20LC-021

STAFF REPORT

1021 Sealy/Avenue I

Request for a Certificate of Appropriateness for modifications to the structure including the installation of replacement front porch rails, columns, balusters, siding, trim, replacement doors and windows; and to relocate the rear accessory structure.

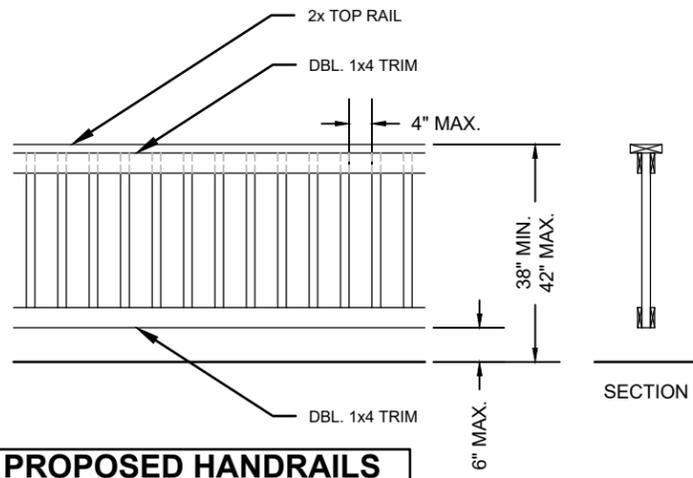
Staff finds that the proposed relocation of the rear accessory structure does not conform to the Design Standards. The Design Standards specifically state that secondary structures should be located along the alley edge.

1. The applicant shall conform to the design, materials and placement indicated in Attachment A in the staff report with the following modifications:
 - a. The relocation of the rear accessory structure shall be omitted;

B PROP. FRONT ELEVATION
Scale: 3/16" = 1'-0"

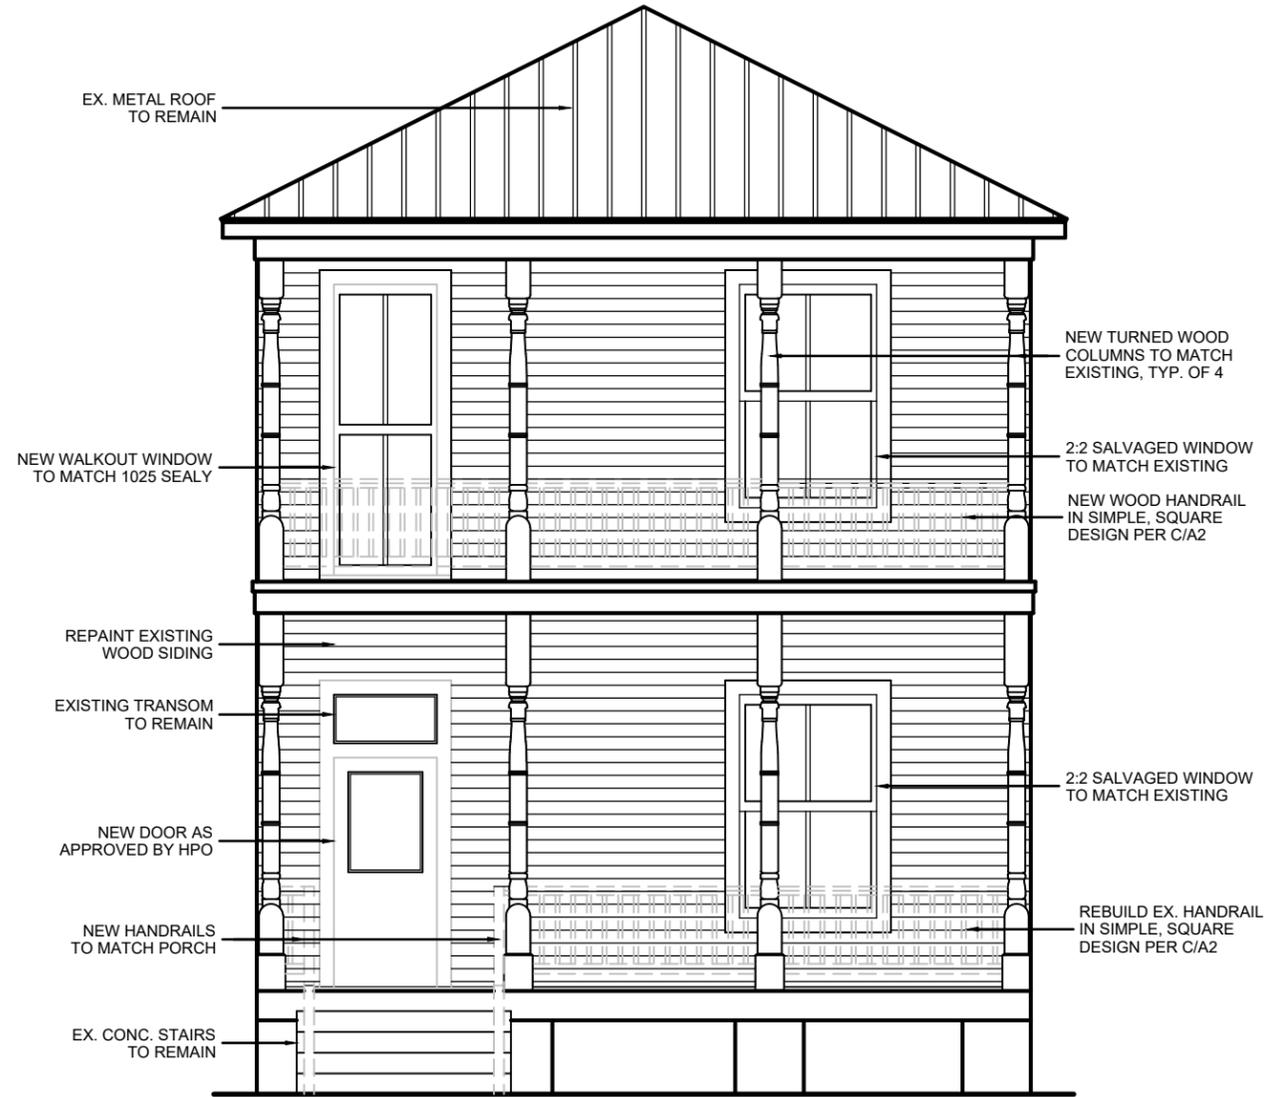
Staff finds the proposed changes to the main structure generally conform to the Design Standards for Historic Properties. Evidence supports the construction of a double gallery on the front façade. Due to the fact that this is a modern reconstruction, it is appropriate to eliminate the decorative details found on the porches of the sister houses so as not to present a false sense of history.
